Brad Boehringer <bradboehringer@gmail.com>
To: Frank H Benesh <frank_benesh@alum.mit.edu>
Cc: andy@ammonoosucsurvey.com
Re: Variance Application

Frank,
Here are detailed responses:

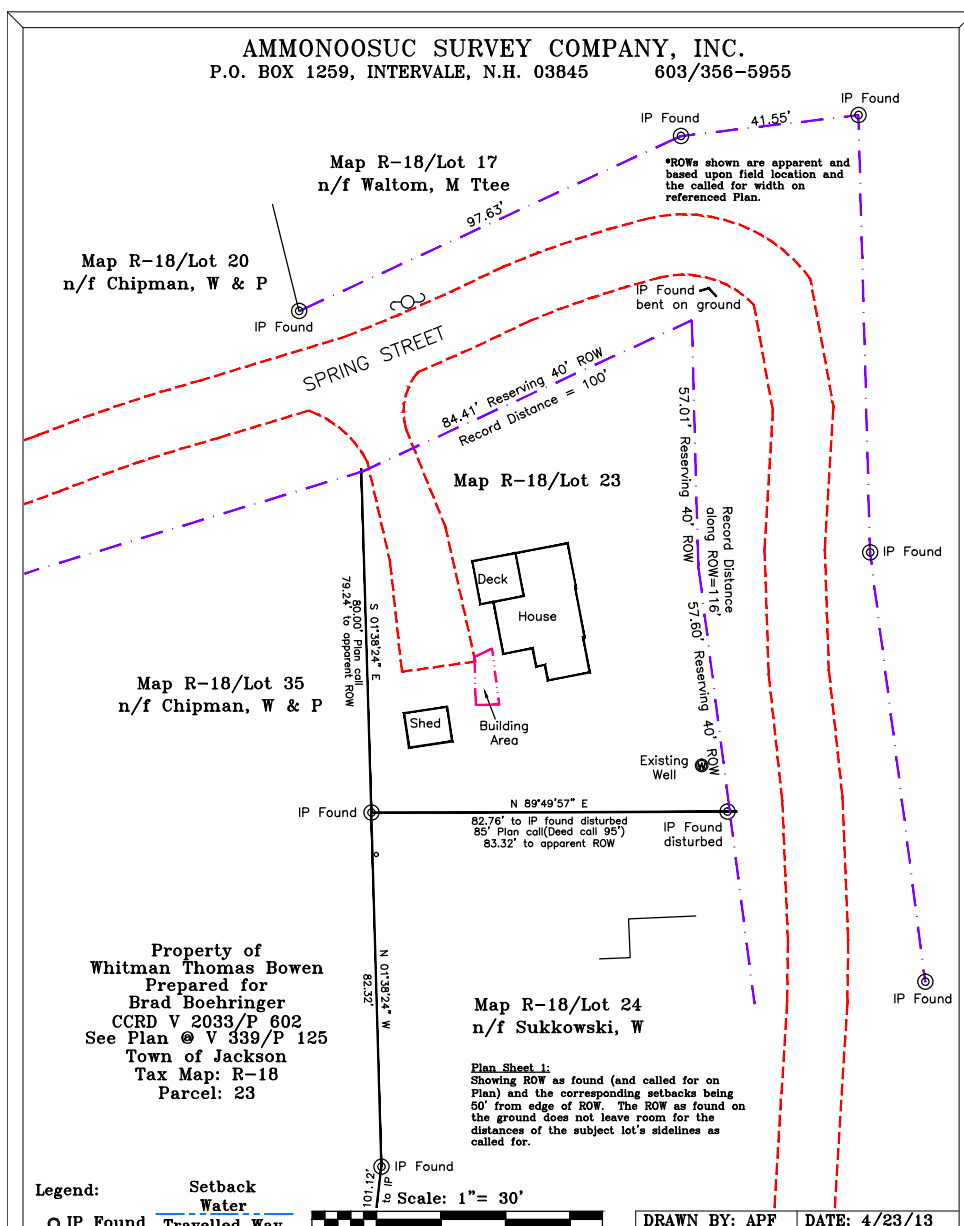
Q. The Ammonoosuc Survey has no date nor signature. Why is that? Will they be providing a signed survey.

Q. The survey appears to depict two possible lot plans, why is that and which is correct.

Q. The survey has a "reserved forty foot ROW" line along both roads, but there is no mention of that on your deed. What is that about?

Q. The proposed drawing does not clearly indicate how much of the new structure is in the proscribed setback.

I had forgotten some of this info as the survey was done nearly two years ago but this was a "preliminary" survey for the following reasons. Ammonoosuc Survey was only able to find 2 of the pins (on the southwest and southeast corners of my property) and extrapolating the boundary lines they basically found discrepancies between the plans as laid out to the town in the subdivision formation and what was realistic based on their actual findings given all of the other surrounding property lines and pins that they could locate. They have laid out the lines given both their best guesses of what the plans predict compared to what they found. See the attached survey schematics. I will try to explain them as best I can:

Boehringer1: this shows the two pins ("IP found") along the southern boundary line. The purple hashed line denotes what would be expected given the 40' right of way as laid out in the subdivision plans. As such the pink box would denote the "buildable area" given strict 50 foot setbacks from the northern and eastern boundary lines.

Boehringer2: this survey is the same as Bohringer1 except with respect to the "buildable area" (pink box). If we are to assume the travelled way that borders the eastern half of my property is a driveway serving the few properties there at the end that would allow me some leeway with the more lenient 25' setback thus expanding the buildable area to include my proposed project.

Boehringer3: this survey delineates with a solid black line my property boundary on the northern and eastern aspect if one was to use the confirmed, two found pins as a foundation and subsequently the measurements (100' as a northern boundary and 116' as an eastern boundary) as outlined on the subdivision plan. This would expand my "buildable area" to what is shown using the strict 50' setbacks on the northern and eastern aspects.

Boehringer4: this survey is the same as the aforementioned except in that it allows for the 50' setback from the northern boundary and a 25' setback from the eastern boundary thus expanding the buildable area as shown by the pink box.

See the above explanation and updated, attached surveys. I hope this will clarify what their thought process is.

The ROW, as I understand it, was on the original design of the subdivision. I've cc'ed Andy from Ammonoosuc Survey so that perhaps he can add some clarity where I fall short on this discussion. It seems like this was the intention of the subdivision in the planning phase but falls short of what is likely in reality.

This depends on how you interpret both the setbacks (50' on both aspects or 50 on one and 25 on the other) and the property lines (using existing road, ROW and listed property measurements on the plan). I hope I have made this clear in the context of your first question.
